1. ACN 1/A authorizes the following changes to Naval Ships Technical Manual, S9086-S3-STM-020, Submarine Firefighting, Chapter 555 Volume 2 Revision 9:

Figure 555-32-2 Portable AFFF Injection Unit (PAIU)

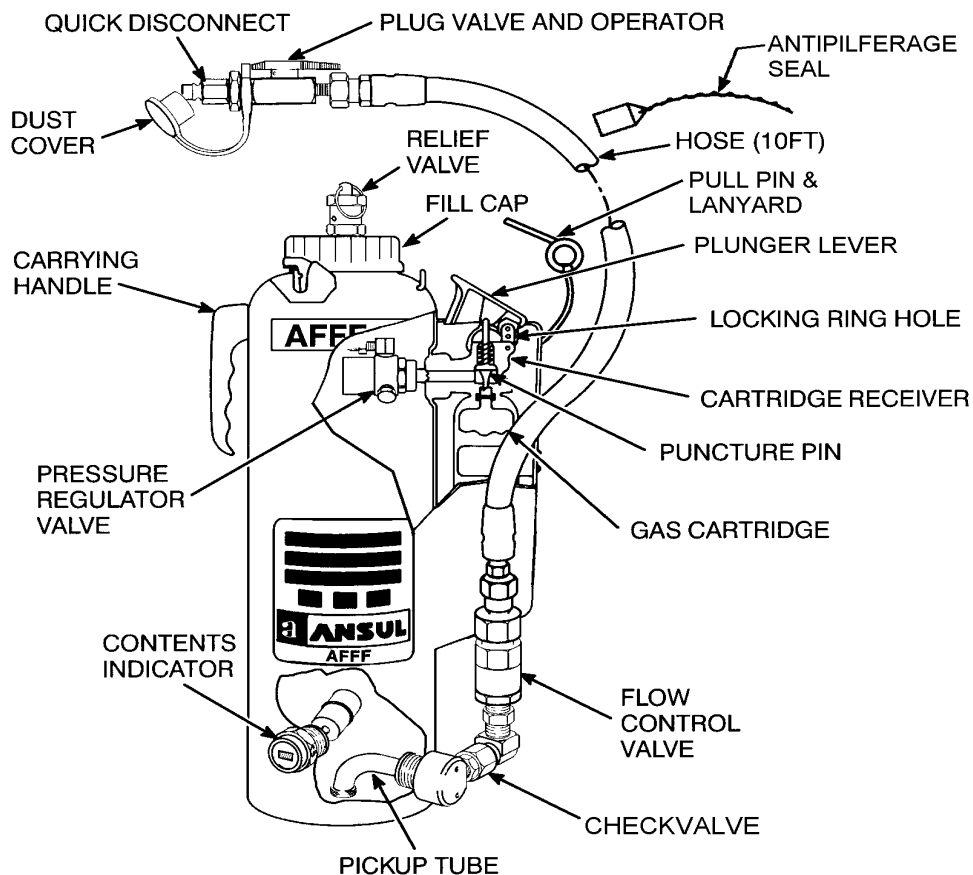
k. Page 555-36, Insert two new sections 555-32.7 and 555-32.8 as follows:

555-32.7.2 DESCRIPTION The PAIU consists of the cylinder assembly and hose assembly, see Figure 555-32-2. The three gallon cylinder has a fill cap with relief valve, carrying handle, contents indicator, discharge fitting, and gas pressure cartridge. The CO2 gas pressure cartridge mounted to the extinguisher shell charges the cylinder through a pressure regulating valve. The discharge hose assembly consists of a check valve, flow control valve, hose, plug valve, and quick disconnect fitting. The hose assembly is ten feet in length. The PAIU is filled with 2.5 gallons of 1 percent AFFF concentrate and will discharge in approximately 2 to 2.5 minutes when connected to a fire hose station. The PAIU will provide an extended discharge time of approximately 6 to 8 minutes when connected to a hose reel or the diesel generator sprinkler system due to an additional flow control device in the station piping line.

Figure 555-32-3 Typical Fire Hose Station with PAIU

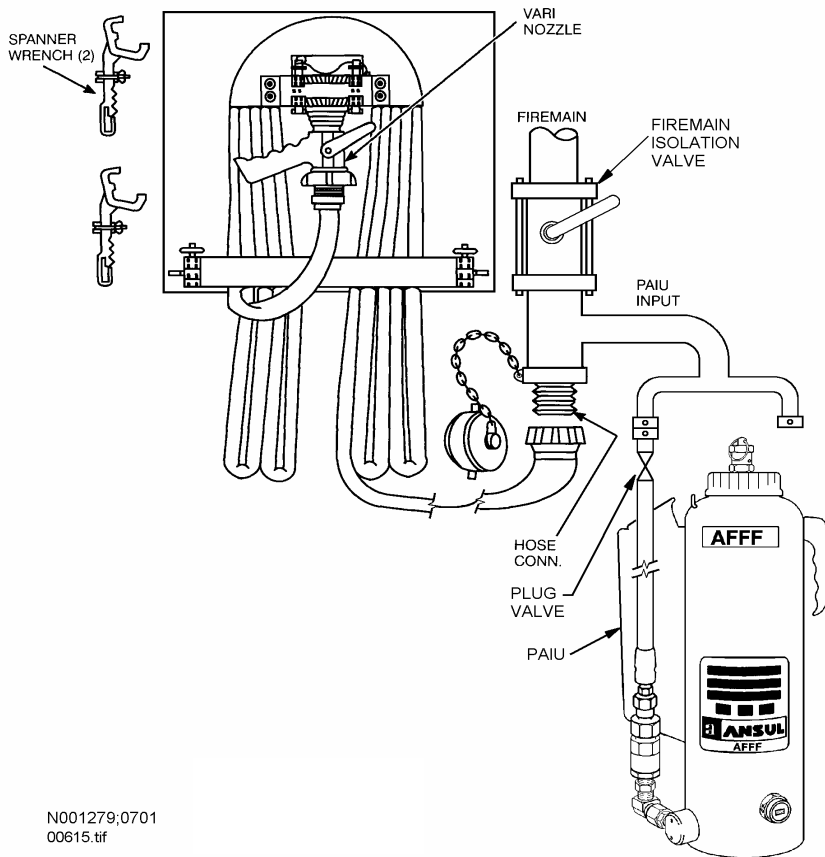
555-32.8.1 DESCRIPTION. SSN 774 Class aqueous film forming foam/seawater (AFFF/SW) firefighting system supplies seawater or AFFF/SW solution to each fire hose station, fire hose reel, and the diesel sprinkler. The system supplies seawater only to the Lockout Trunk (LOT) sprinkler to protect ordnance when stowed in the LOT, to the Small Arms Ammunition and Pyrotechnics Locker, and to the aft chlorate candle locker standpipe. AFFF used on VIRGINIA Class is 1% Concentrate (1 part concentrate to 99 parts water). AFFF is stored in portable AFFF injection units (PAIU) located at each fire hose station and hose reel. See Figure 555-32-3 for typical fire hose station with PAIU arrangement."

Figure 555-35-16 SSN 774 Class, Fire In Port, Natural Ventilation Desmoking of Forward Compartment

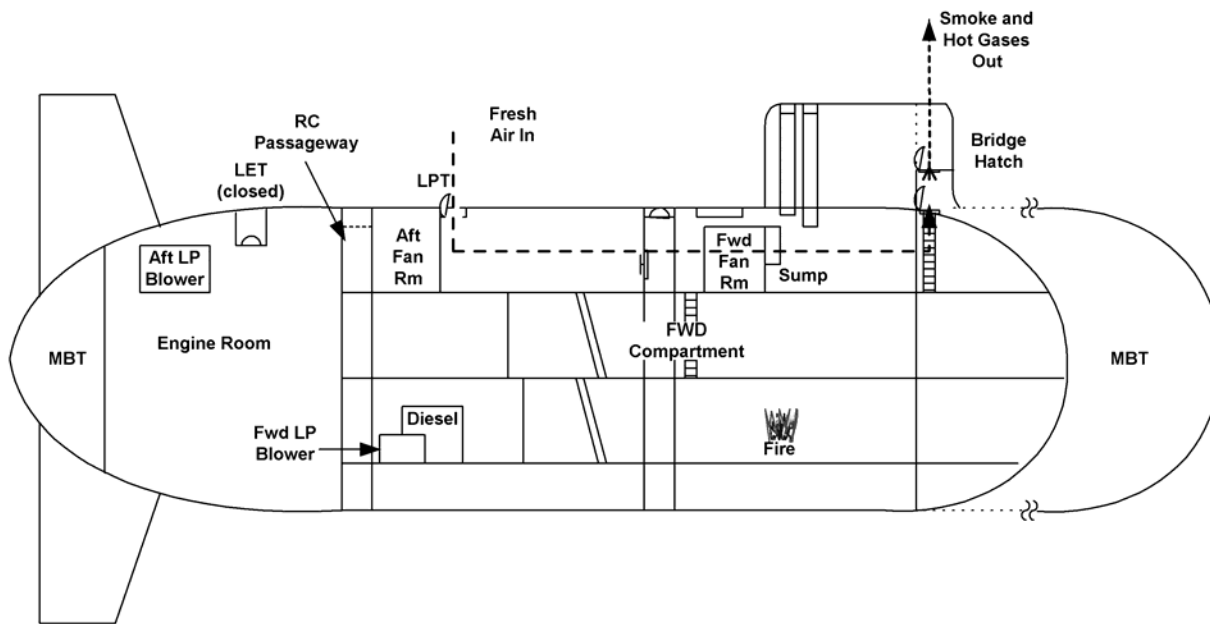
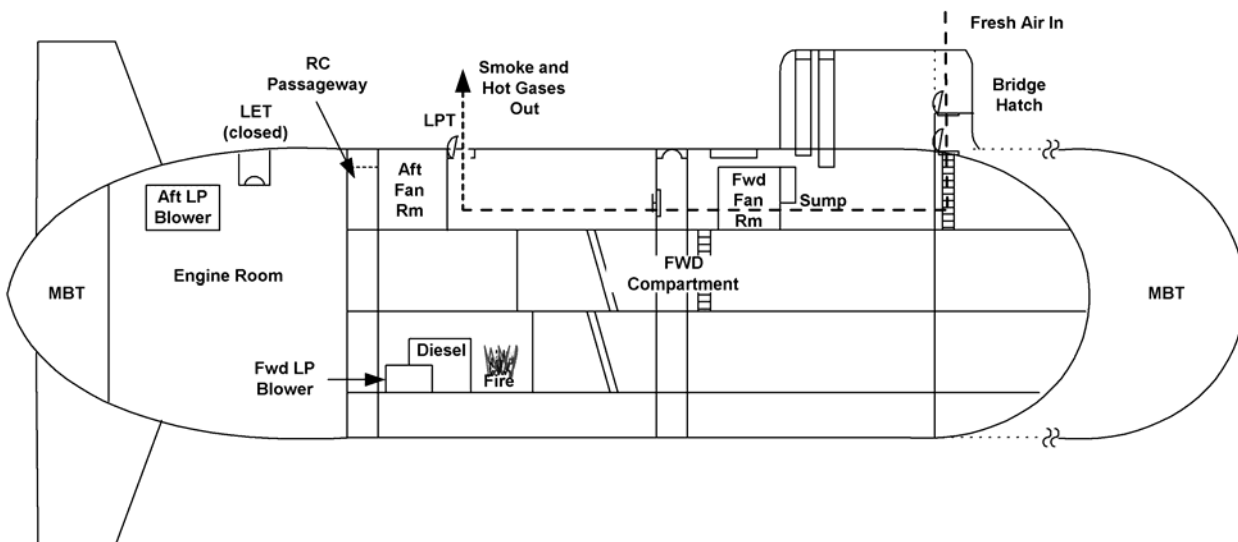
ag. After Page 555-106 Insert new: Figure 555-35-16, SSN774 Class, Fire In Port, Natural Ventilation Desmoking of Forward Compartment

(2) Add new last sentence: "For SSN774 Class fire, in port, in the forward compartment see Figure 555-35-16 and VIRGINIA Class SSMS."

Figure 555-35-17 SSN 774 Class, Fire in Port, Mechanical Ventilation Desmoking of Forward Compartment.

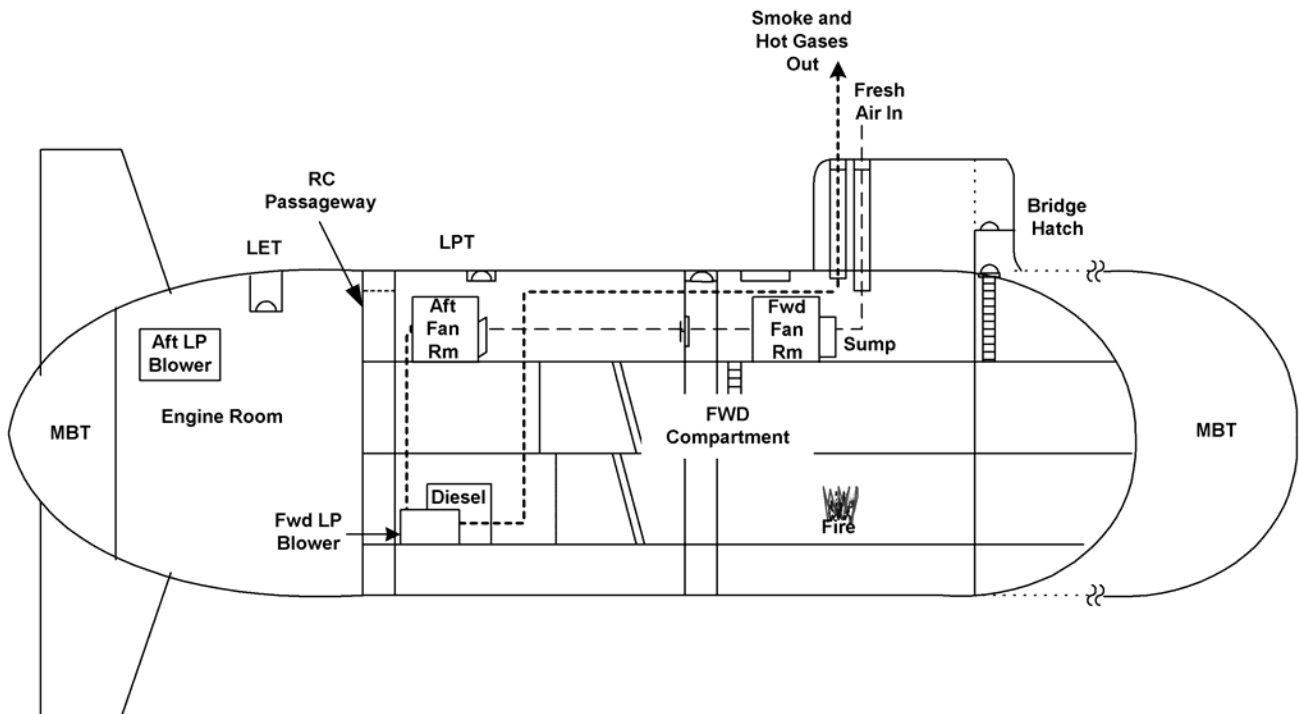
ah. After Page 555-106 Insert new: Figure 555-35-17 SSN774 Class, Fire In Port, Mechanical Ventilation Desmoking of Forward Compartment

(1) Delete first two sentences that read "For SSN 688 class and SSN 21 class submarines, mechanical desmoking is needed only when natural ventilation desmoking is not effective. For SSN 688 Class see Table 555-35-1, Figures 555-35-11 and 555-35-16, for SSN 21 Class see Table 555-35-1B, Figures 555-35-15 and 555-35-20." and substitute: "For SSN 688 class, SSN 21, and SSN774 class submarines, mechanical desmoking is needed only when natural ventilation desmoking is not effective. For SSN 688 Class see Table 555-35-1 and Figure 555-35-11, for SSN 21 Class see Table 555-35-1B, Figures 555-35-15 and 555-35-20, for SSN-774 Class see Figure 555-335-17 and VIRGINIA Class SSMS."

Figure 555-35-18 SSN774 Class, Fire In Port, Natural Ventilation Desmoking of Engine Room

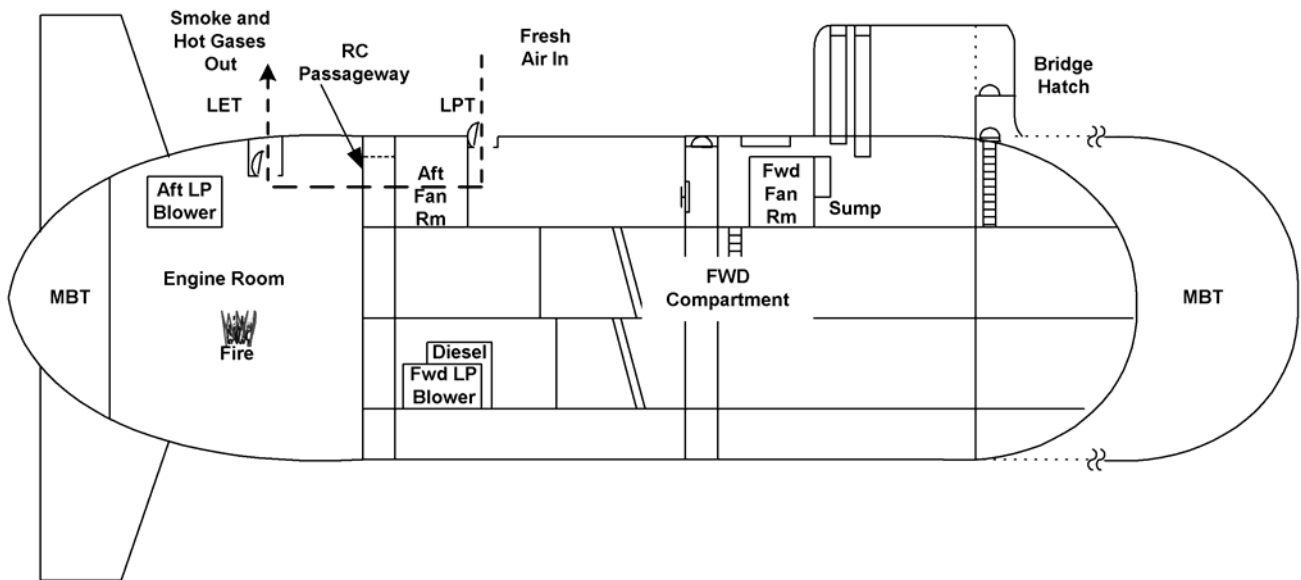
ai. After Page 555-107 Insert new: Figure 555-35-18 SSN774 Class, Fire In Port, Natural Ventilation Desmoking of Engine Room

Figure 555-35-25. SSN 774 Class, Fire At Sea, Mechanical Ventilation Desmoking of Forward Compartment.

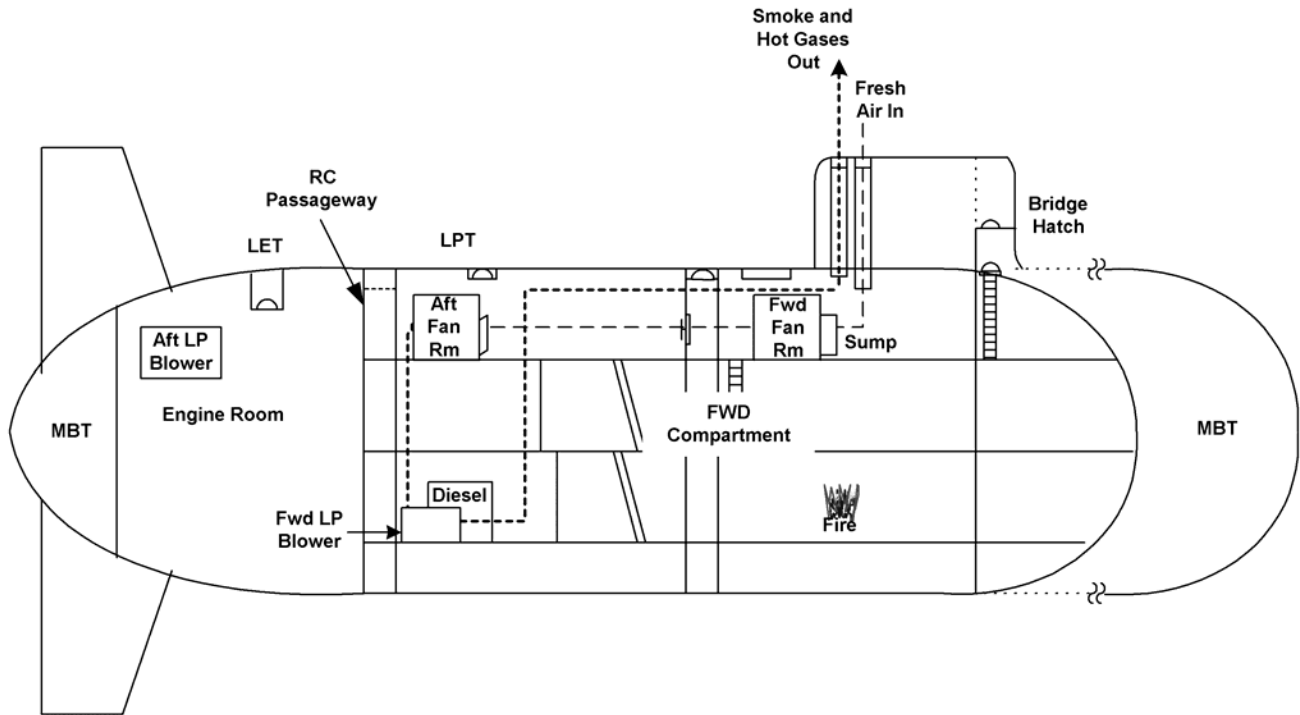
at. Page 555-114, Insert new Figure 555-35-25 SSN 774 Class, Fire At  
Sea, Mechanical Ventilation Desmoking of Forward Compartment

av. Page 555-119, paragraph 555-35.8.4.2 Delete first two sentences that read, "For a fire while underway in any forward compartment location for SSN 688 class and SSN 21 class submarines, except the control room, the preferred method is mechanical ventilation desmoking. Mechanical desmoking is done by exhaust through the control room emergency ventilation terminal and a bridge hatch fresh air supply; use either LP blower or diesel engine, see Table 555-35-2, Figure 555-35-16 and Figure 555-35-20." And substitute, "For a fire while underway in any forward compartment location for SSN 688 class, SSN 21 and SSN 774 Class submarines, except the control room, the preferred method is mechanical ventilation desmoking. For SSN 688 class and SSN 21 class, mechanical desmoking is done by exhaust through the control room or galley emergency ventilation terminal with a bridge hatch fresh air supply; use either LP blower or diesel engine, see Table 555-35-2, Table 555-32-B, and Figure 555-35-16, and 555-35-23. For SSN 774 Class, see Figure 555-35-25 and VIRGINIA Class SSMs."

Figure 555-35-26 SSN 774 Class, Fire At Sea, Mechanical Ventilation Desmoking of Engine Room

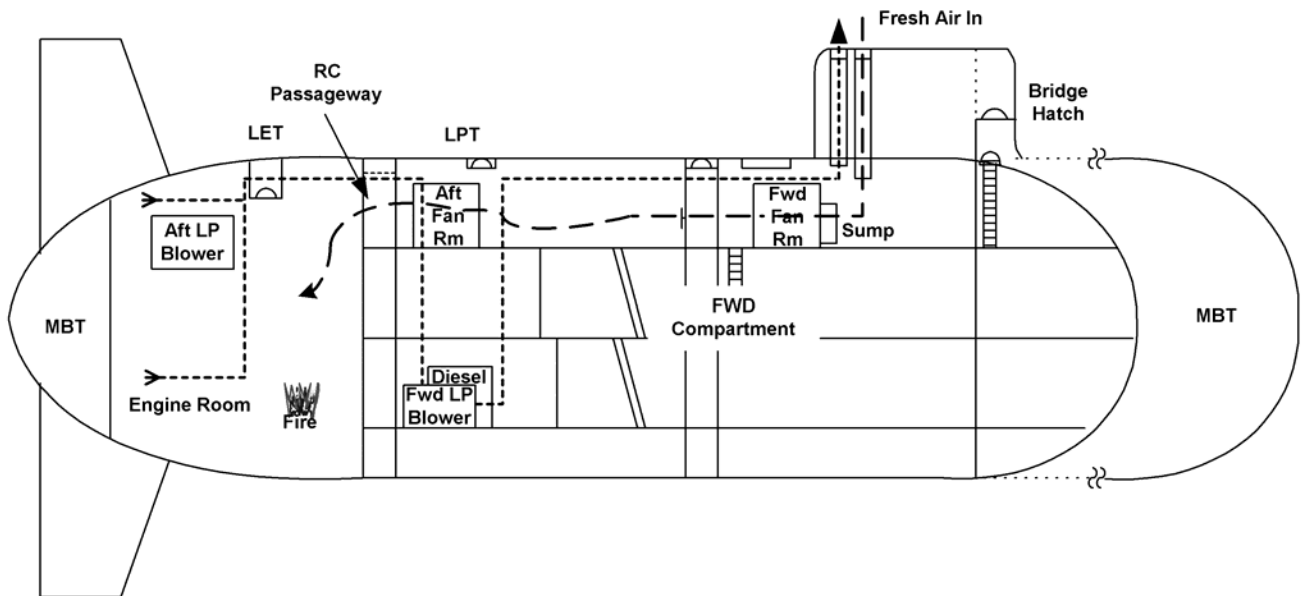
au. Page 555-114, Insert new Figure 555-35-26 SSN 774 Class, Fire At  
Sea, Mechanical Ventilation Desmoking of Engine Room

ax. Page 555-121, Insert new paragraph, "555-35.8.4.4.4 SSN 774 Class. For SSN-774 class submarines while underway, see Figure 555-35-26 and VIRGINIA Class SSMs."
